When using a panel model '34' both warning lights and meters, for coolant temperature and oil pressure have to be operated.

Installation of interface and interface cable on '34' model panel

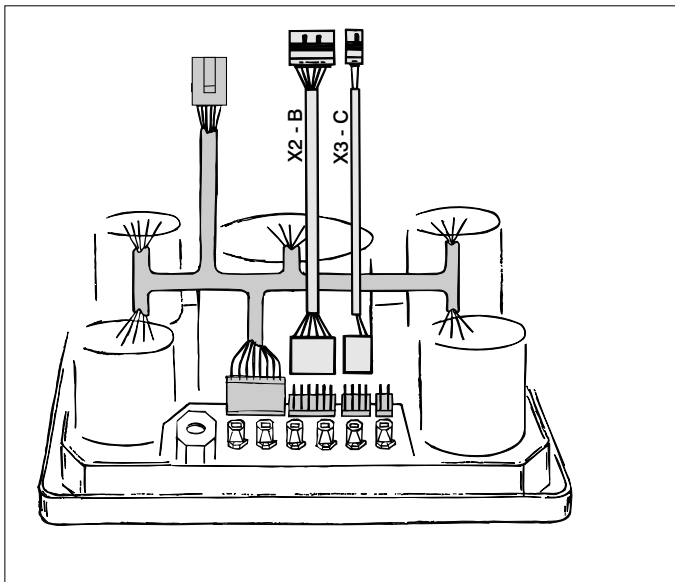
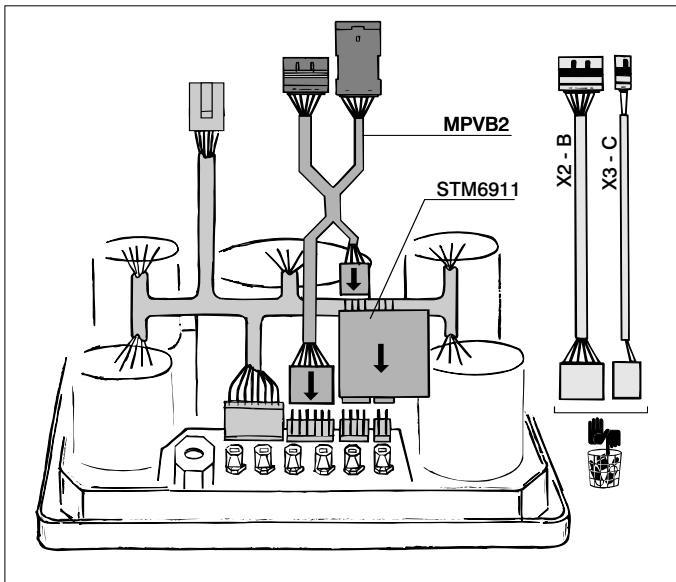
Installation of both switches for warning lights and sending units for meters into the engine block is not possible. Therefore some minor modifications have to be carried out:

- At the panel the factory installed connection cables (X2->B and X3->C) have to be replaced by an interface [STM 6911] and an interface cable [MPVB2].
- At the engine the factory installed switches have to be replaced by sending units, adaptors and washers are required.

On panel, remove connection cables, X2 ⇔ B and X3 ⇔ C, from warning light printed circuit board (pcb).

Install interface pcb [STM6911] onto warning light pcb. Connect Interface cable [MPVB2] to warning light pcb and to interface pcb.

Replacing switches for sending units

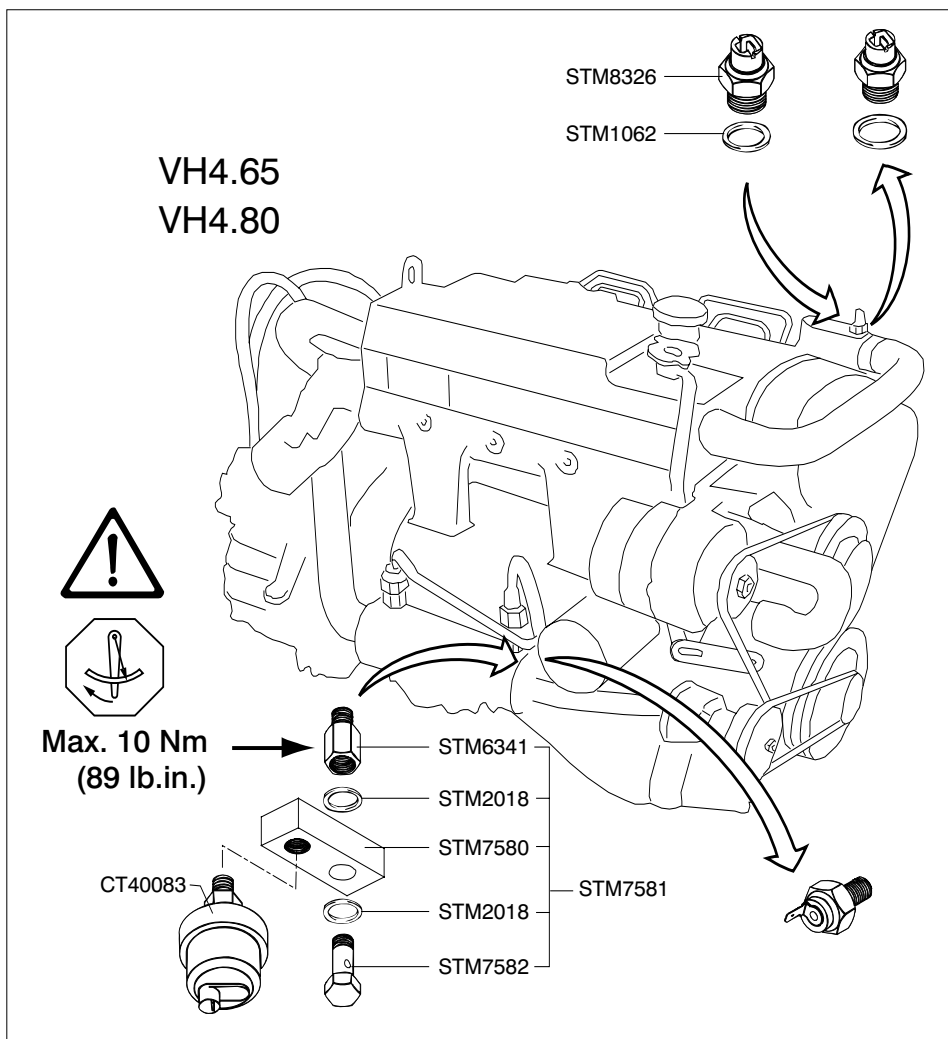
- On engine, loosen wire nr. B5 (blue) from the thermo switch. Replace factory installed thermo switch by: Temperature sending unit, adaptor and copper washers. Reconnect wire B5 to temperature sensor.
- Loosen wire nr. B2 (brown) from the oil pressure switch. Replace factory installed oil pressure switch by: Oil pressure sending unit, adaptor, adaptorblock, bolt and washers. Reconnect wire B2 to oil pressure sensor.
